**RE: RESPONSE TO COUNCIL'S FURTHER ADVICE - MINOR CHANGE APPLICATION UPON LAND AT 7-11 & 11A SARGENT STREET, NEW FARM (COUNCIL REFERENCE: A006989439)**

We write in relation to the abovementioned application upon 7-11 & 11A Sargent Street, New Farm (Lot 3 on RP128712, Lots 41 & 119 on RP8765), and the comments that were issued by Council and received via email on 14 May 2026. We hereby provide the following response.

Figure 1: Proposed Card Reader Design (Source: FK Architects)

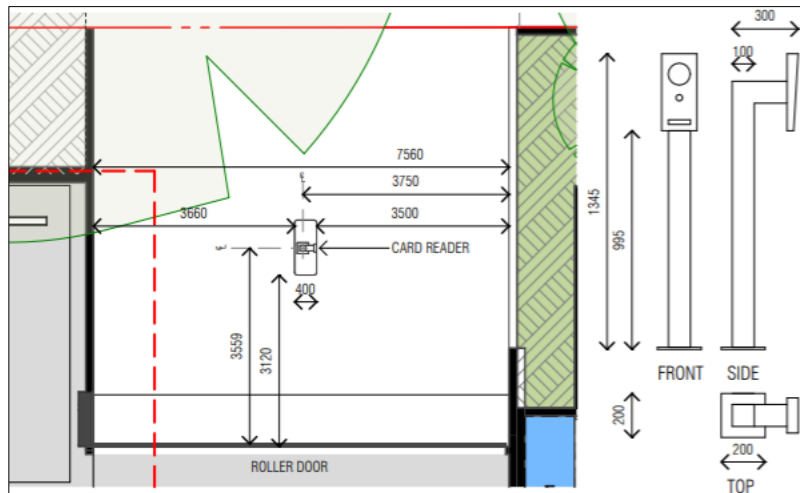
*1. It is noted the addition of a card reader has been made within the internal driveway, amended swept path analysis and quantification of the card reader must be provided.*

- a. Provide amended plans which clearly demonstrate the specific positioning of the card reader within the internal driveway and its size (width, depth, height).*

As requested, an updated plan is enclosed showing the positioning and size of the proposed card reader in the driveway. An excerpt of the card reader's dimension and size is shown in Figure 1. Please refer to Updated Architectural Plans by FK Architects for further details.

Figure 2: Sight Distances and Proposed Yellow Line Locations (Source: PTT)

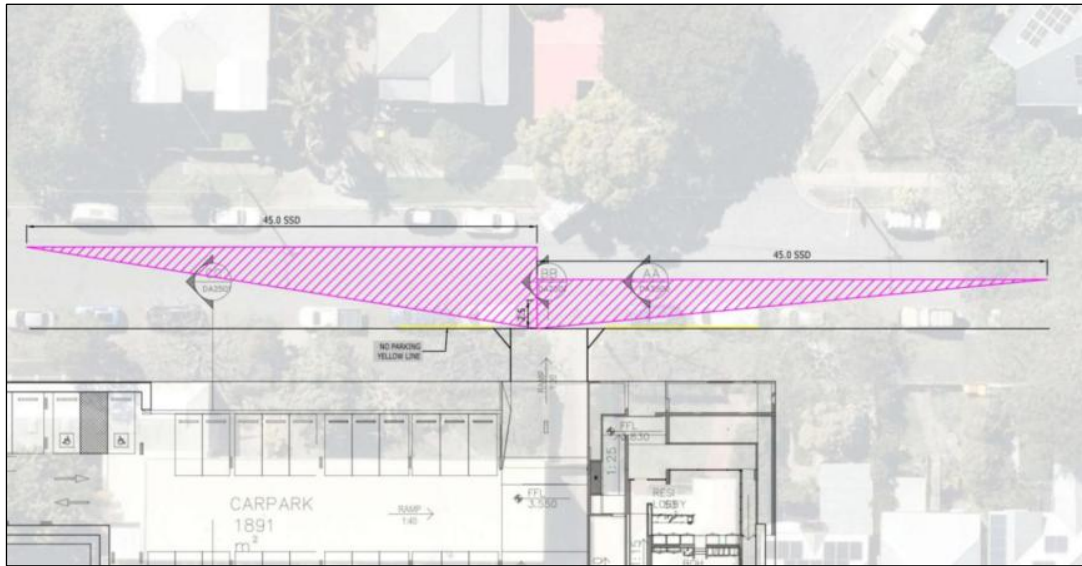
- b. Provide updated swept path which demonstrates the egress manoeuvre of the RCV is functional whether on street parking is occupied or not, noting vehicles can lawfully park immediately adjacent the kerb taper of the crossover.

PTT have conducted an assessment of the existing on-street parking spaces, specifically with the lawful on-street spaces immediately adjacent to the development's access crossover tapers. As detailed in the Traffic Response Letter by PTT, Council's Transport, Access, Parking and Servicing Planning Scheme Policy (PSP) requires a minimum sight distance of 70m for the development whereas the Australian Standards AS2890.1 requires an minimum sight distance of 45m. Specifically, Sargent Street is classified as a Neighbourhood road under the Road hierarchy overlay being the lowest classification in the hierarchy. Furthermore, Sargent Street is a residential street with a maximum speed limit of 50km / hr. In comparison to other surrounding Neighbourhood Roads, such as Oxlade Drive and Sydney Street, Sargent Street has a comparability lower yield traffic (Less than 100 vehicles per hour).

Due to site's context being a low-speed urban environment and taking into consideration the demand for for on-street parking in the area, the proposal has adopted the Australian Standards requirement of a minimum 45m sight distance. As such, the applicable Australian Standard notes that parking on the frontage of a road may need to be restricted on either side of a driveway so that minimum sight distances can be achieved (Refer to Figure 2). It is proposed to provide 'No parking' yellow lines to restrict on-street parking in order to demonstrate compliance with the relevant Australian Standard.

Figure 3: Updated RCV Swept Path Plans (Source: PTT)

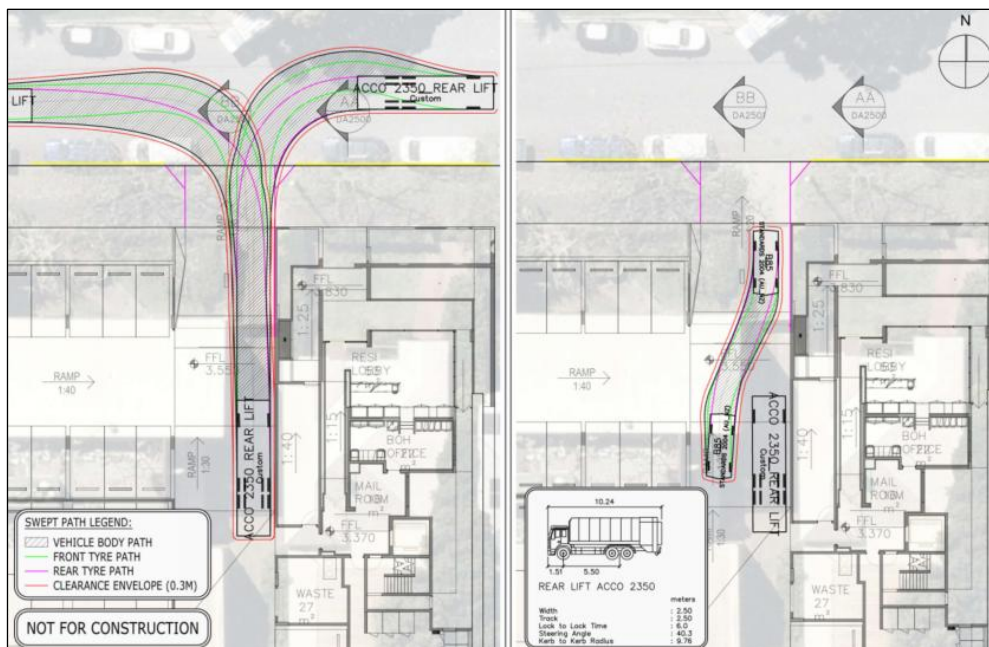
- c. Provide updated RPEQ RCV swept paths which demonstrate a kerb to kerb of 9.757m as per BSD-3009 or provide clarification from an RPEQ that the steering angle utilised to generate the swept path is equivalent to a kerb to kerb radius of 9.757m. “

RCV swept paths have been updated with the proposed restrictions of the immediately adjacent on-street car parking spaces in front of the development and to demonstrate that the proposed card reader will not conflict with vehicle turning circles. RCV swept paths are shown below in Figure 3. Refer to the Traffic Response Letter by PTT for further details.
